DEVELOPMENT REVIEW BOARD PANEL A AGENDA

2. [Resolution No. 436 OrePac Site Improvements. The applicant is requesting approval of a Zone Map Amendment, Stage 1 Preliminary Plan, Stage 2 Final Plan, Site Design Review, Lot Line Adjustment, Right-of-Way Vacation, and Type C Tree Plan for site improvements at the OrePac properties located at 30160 & 30170 SW OrePac Avenue, 30445 SW Boones Ferry Road, and 9655 SW 5th Street.](#)

Exhibit A1
Staff Report
Wilsonville Planning Division
OrePac Site Improvements
Development Review Board Panel 'A'
Quasi-Judicial Public Hearing

SHEET TITLE:
PLANTING PLAN

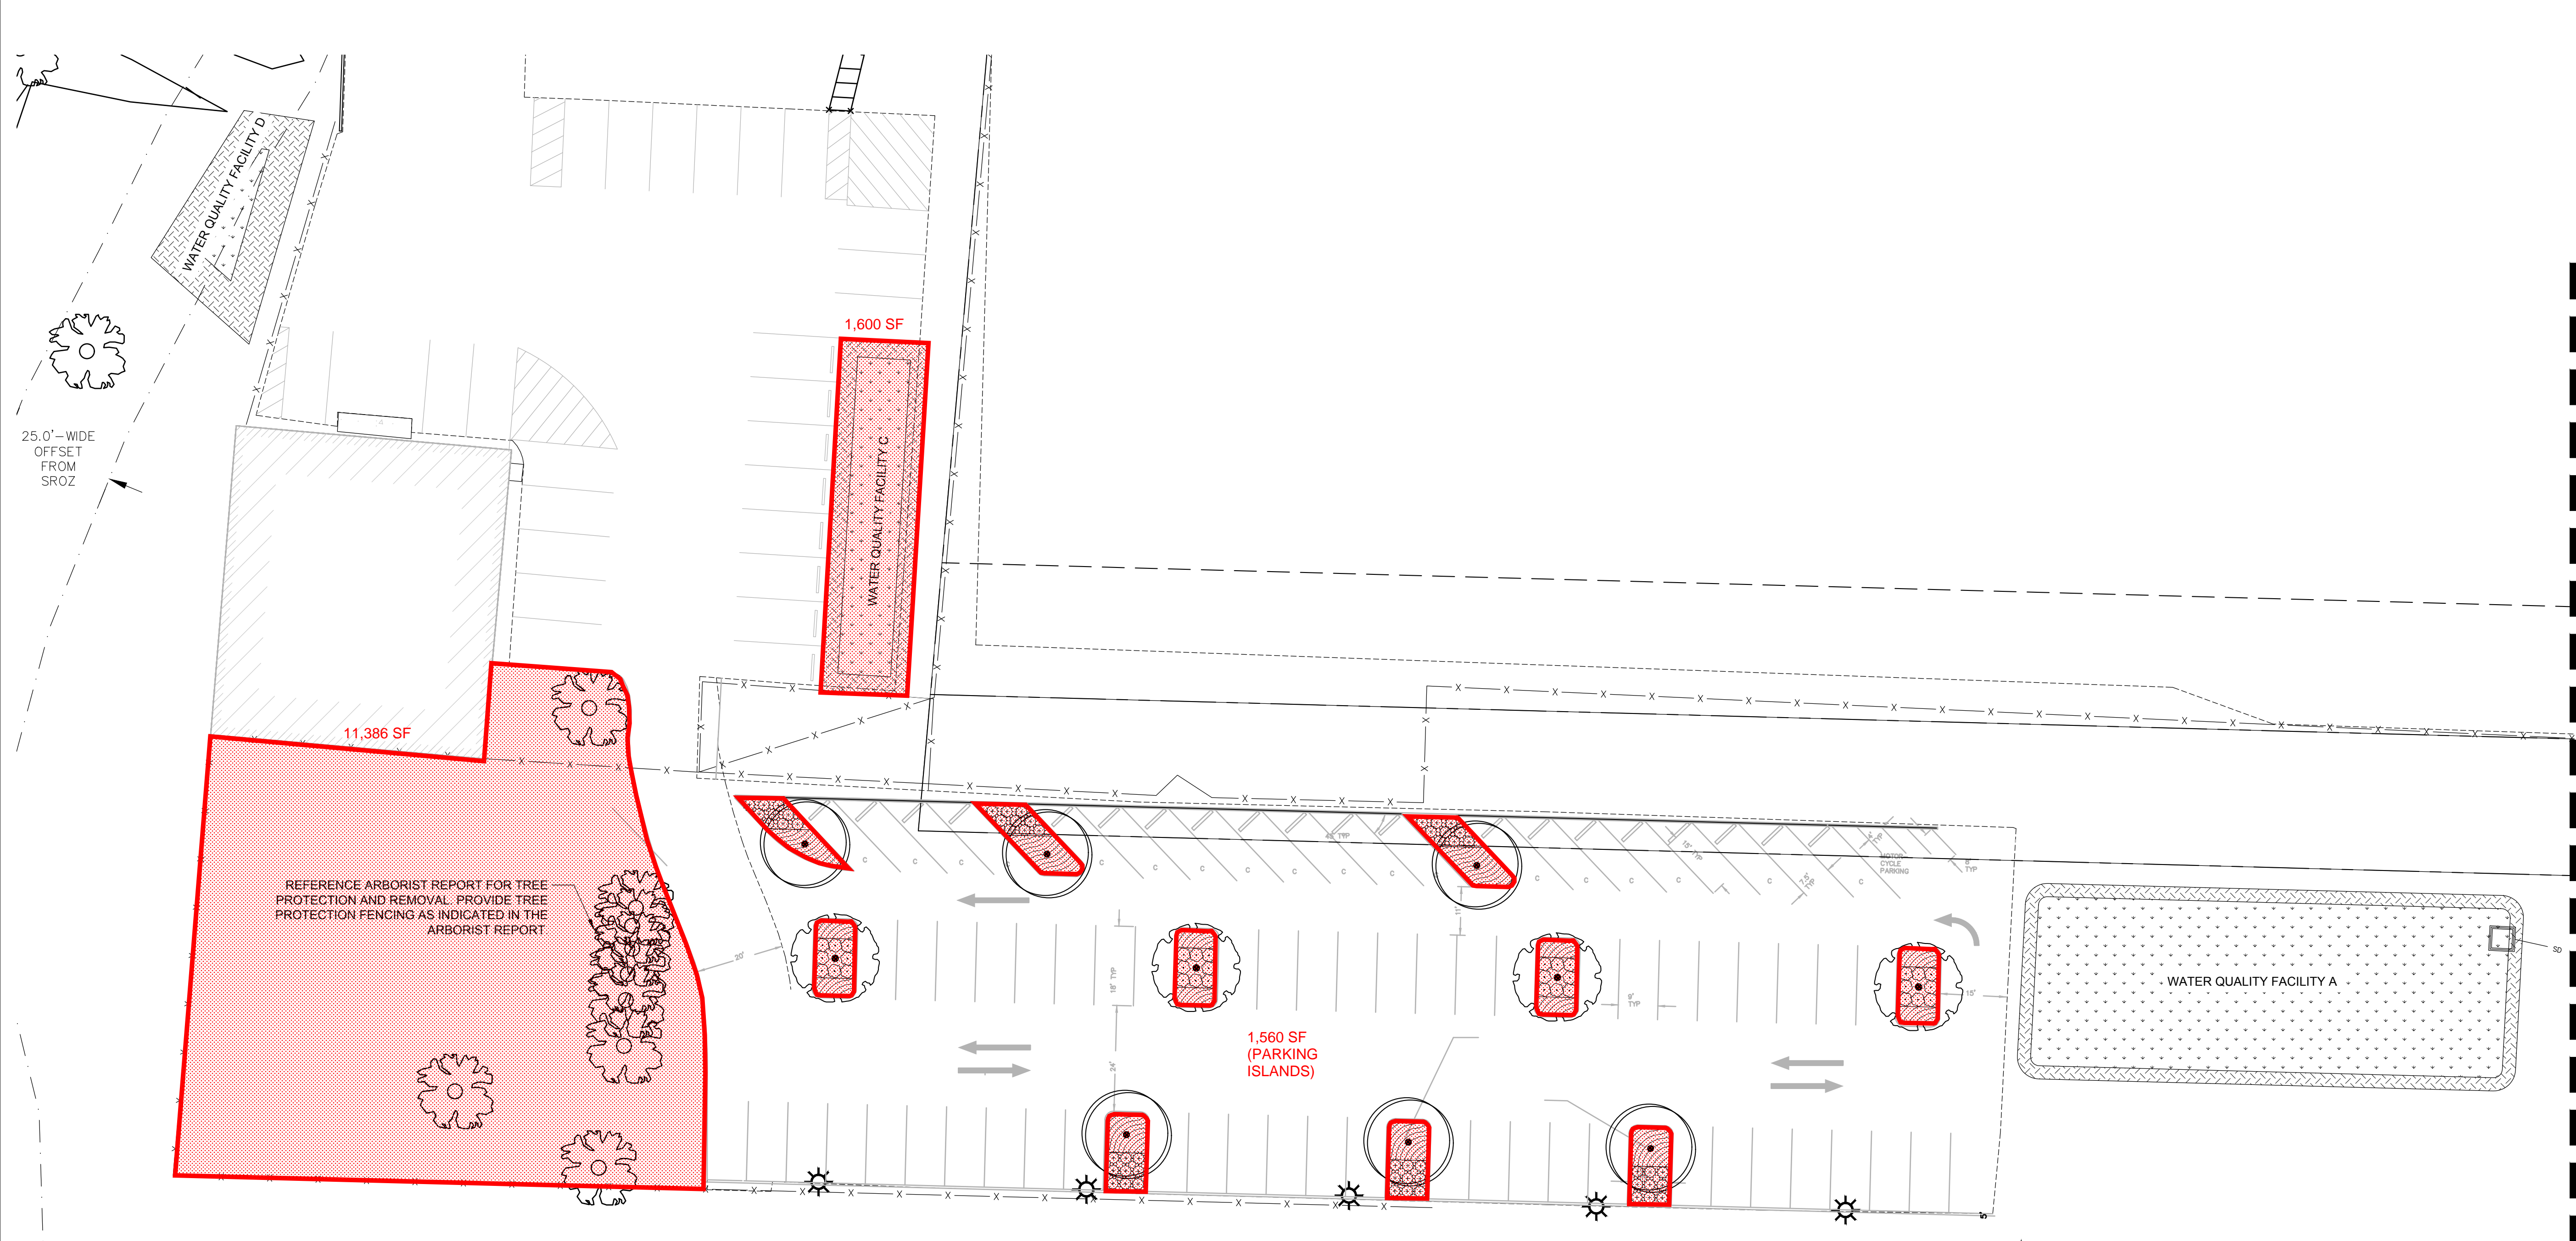
- Parking Lot Landscaping – Section 4.155 (.03) B.: Why are there no landscape islands or landscaping proposed (Sheet L1.10) in the new northern parking area? Are existing trees along the north and east sides being considered parking lot landscaping? That is correct, the areas in blue boxed in the image below are considered as landscape islands and are provided at an aggregate from the northern parking lot area. The impervious area of the L-shaped parking area is ~15,850 SF, and approximately ~5,200 SF of parking area landscaping is provided, satisfying the 10% requirement. These areas have mature trees which will provide shade to the parking area. Additionally, the new storm facility in the northern parking area is a vegetated facility that can provide similar landscaping qualities.
